Product Change Notification

Change Notification #:	**113682 - 00**
Change Title:	**Intel® SSD DC P3600 Series (1.2TB, 1.6TB, 2.0TB, 400GB, 800GB 2.5in PCIe 3.0, 20nm, MLC), Intel® SSD DC P3700 Series (1.6TB, 2.0TB, 400GB, 800GB 2.5in PCIe 3.0, 20nm, MLC), PCN 113682-00 Product Material Enclosure Second Source**
Date of Publication:	**March 10, 2015**

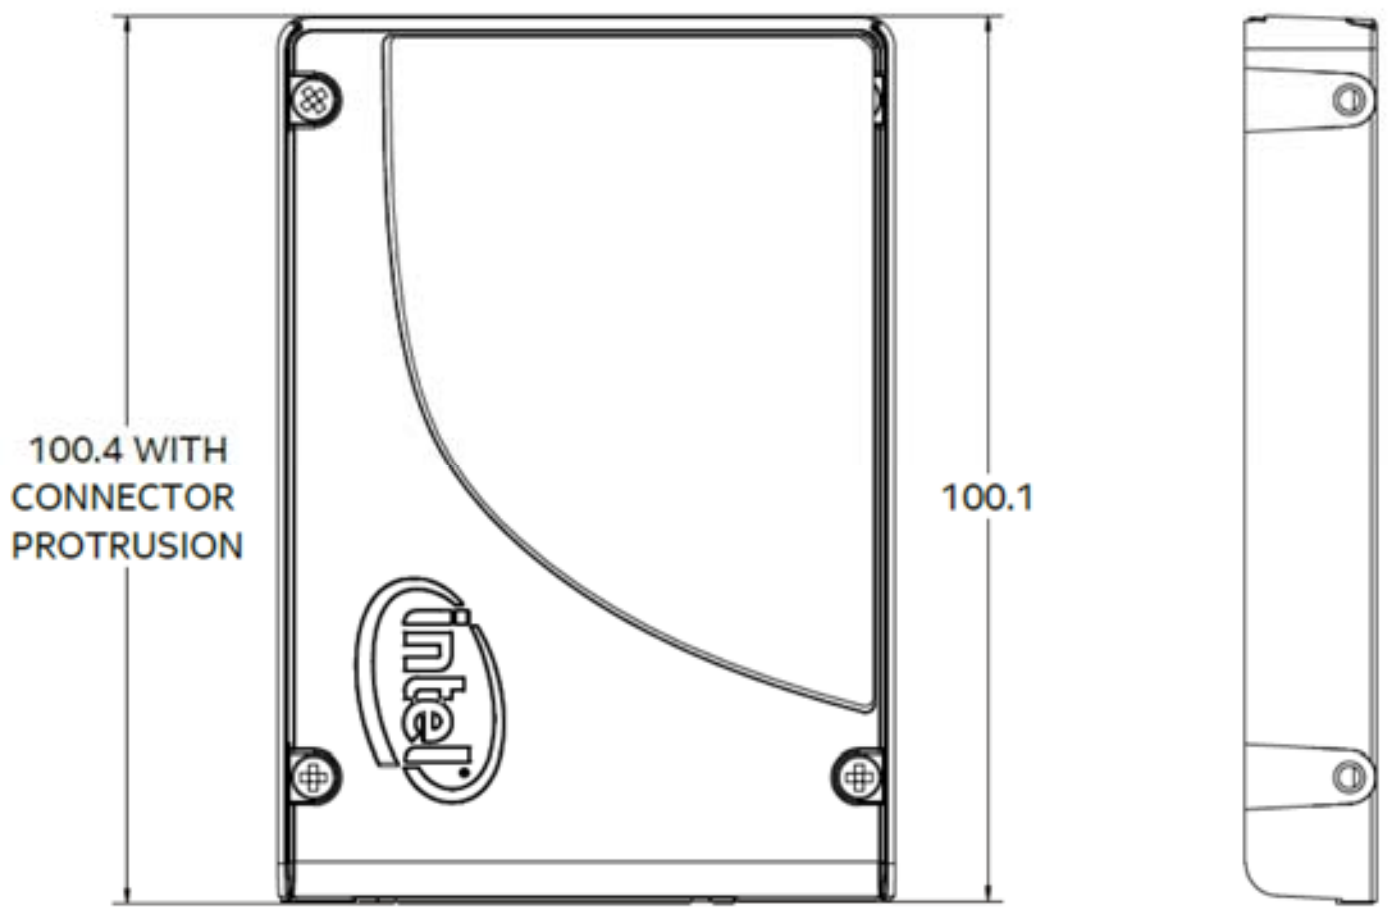
Intel has qualified a second source supplier for the Intel® SSD DC P3700 and P3600 2.5in x 15mm SFF-8639 form factor enclosure. The second source enclosure meets and passes Intel mechanical and dimension requirements, as well as mechanical required tests. These include temperature cycling, temperature humidity bias, shock and vibe. Please contact your Intel representative for full test results.

Primary source is pictured on the top while the secondary source is shown on the bottom.

Since the new enclosure meets the same required quality and reliability criteria as the primary, Intel is not recommending that a customer take any action. The new enclosure meets the current requirements of the SSD Form Factor specification for SFF-8639 enclosure, as well as Intel criteria for form, fit, function, and reliability.
